XT30 and XT50 Series Panels March 2010

Software Update

TU-0394 © 2006 Digital Monitoring Products, Inc.

Canadian In Touch Messaging

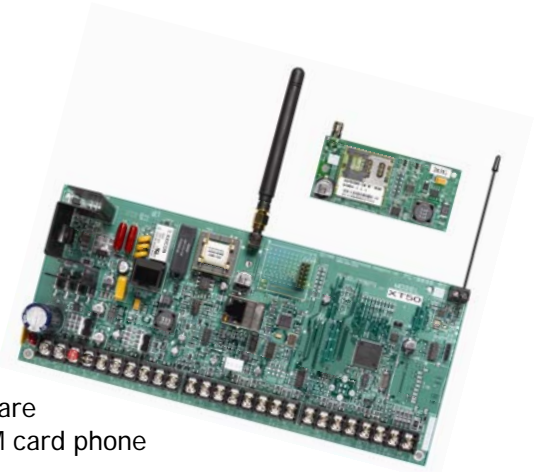
The XT30 and XT50 Series panels now support In Touch™ SMS text operation in Canada using the 263GCAN Digital Cellular Communicator. The 263GCAN includes a SIM card provided by Rogers Wireless Cellular Network.
